Amendment 39-5338; AD **72-06-05** R2

Airworthiness Directives; MARVEL SCHEBLER (Facet Aerospace Products Company): Applies to Models MA-3, MA-3A, MA3-PA, MA-3SPA, MA4-SPA, MA4-5, MA4-5AA, MA-5, MA-5AA, MA-6AA and HA-6 Carburetors

**72-06-05 R2 MARVEL SCHEBLER (Facet Aerospace Products Company):** Amendment 39-1411 as amended by Amendment 39-1685 is further amended by Amendment 39-5338. Applies to Models

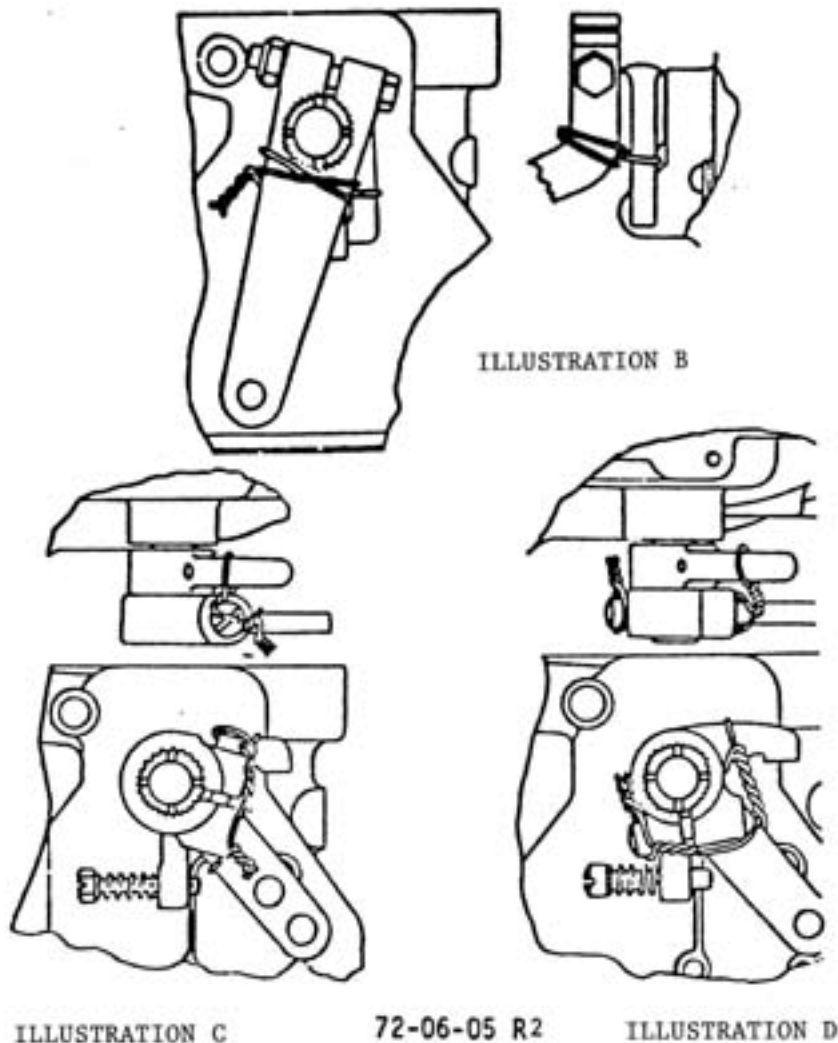
- (2) Inspect the throttle arm on Marvel Schebler MA-3, MA-3A, MA-3PA, MA3-SPA, and MA-4SPA carburetors to determine whether it has a spotfaced or milled flat for the head of the clamping screw. Replace any arm having a milled flat with one having a spotfaced flat. If not already installed, install a Marvel Schebler P/N A15-493 clamping screw (No. 10-24 x 5/8 slotted drilled fillister head) in the throttle arm. Torque the clamping screw to 20-28 in.-lb. and inspect the slot in the end of the arm for clearance. If the slot has closed so that no clearance remains, replace the arm and retorque to the above specifications. After the specified torque is established safety wire the throttle arm and clamping screw to the throttle stop as shown in Illustration A.

- (3) On Marvel Schebler MA-4-5, MA4-5AA, MA-5AA, MA-6AA, and HA-6 series carburetors with throttle arms having a 10-32 bolt and nut clamping the arm on the throttle stop, torque the nut to 35 to 40 in. lbs. and safety wire the throttle arm to the throttle stop as shown in Illustration B. On these series carburetors having a throttle arm threaded for a 10-24 screw, if not already installed, install a Marvel Schebler P/N A15-493 clamping screw (No. 10-24 x 5/8 slotted drilled fillister head) in the throttle arm

and torque the screw to 20 to 28 in. lbs. Safety wire the throttle arm to the throttle stop as shown in Illustration C or D.
